UNITED STATES ENVIRONMENTAL PROTECTION AGENCY

This letter constitutes conditional approval of the Work Plan for the RI and FS for the Henderson Road NPL Site Landfill Operable Unit, received at EPA on September 14, 1988. According to the Compliance Schedule for the Landfill Operable Unit which was transmitted with my November 2, 1987 letter to you and reflected agreements reached with the PRPs at previous meetings, a draft RI and Phases 1 and 2 of the FS are due to EPA within four weeks of receipt of these comments. A copy of the November, 1987 Compliance Schedule, which is incorporated into the Consent Order, is attached; I corrected the schedule on page 95 of the Work Plan to reflect the actual commitments stipulated in the Compliance Schedule.

Enclosure 2
GDV comments
submitted 10/14/88
to BCM

WORK PLAN
FOR THE
REMEDIAL INVESTIGATION AND FEASIBILITY STUDY
HENDERSON ROAD SITE
LANDFILL OPERABLE UNIT

**Figure
Geologic Map**

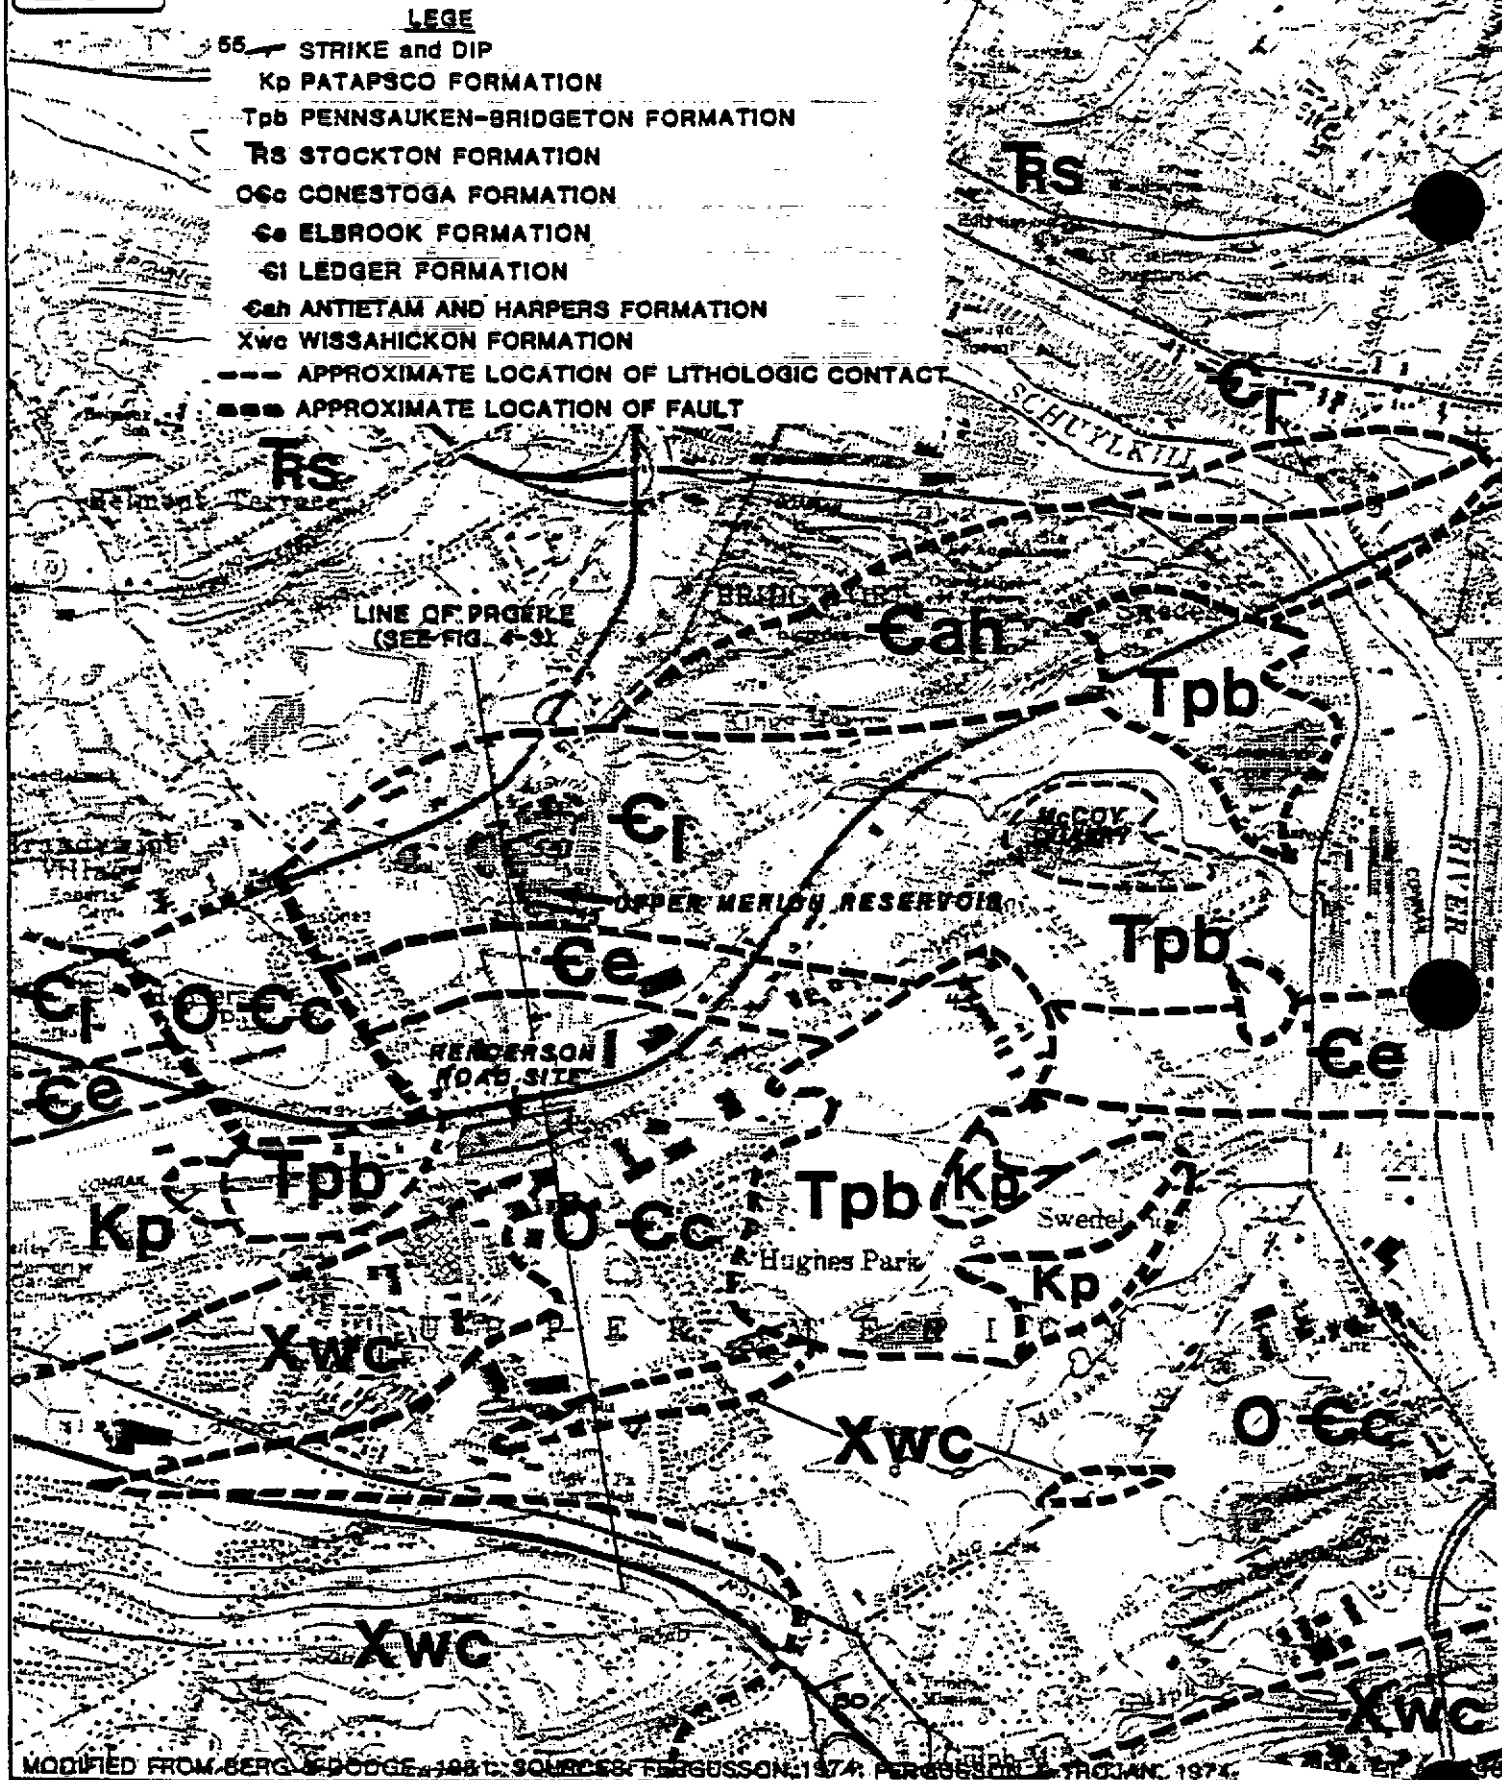
PI must address ground water classification of aquifer beneath site.
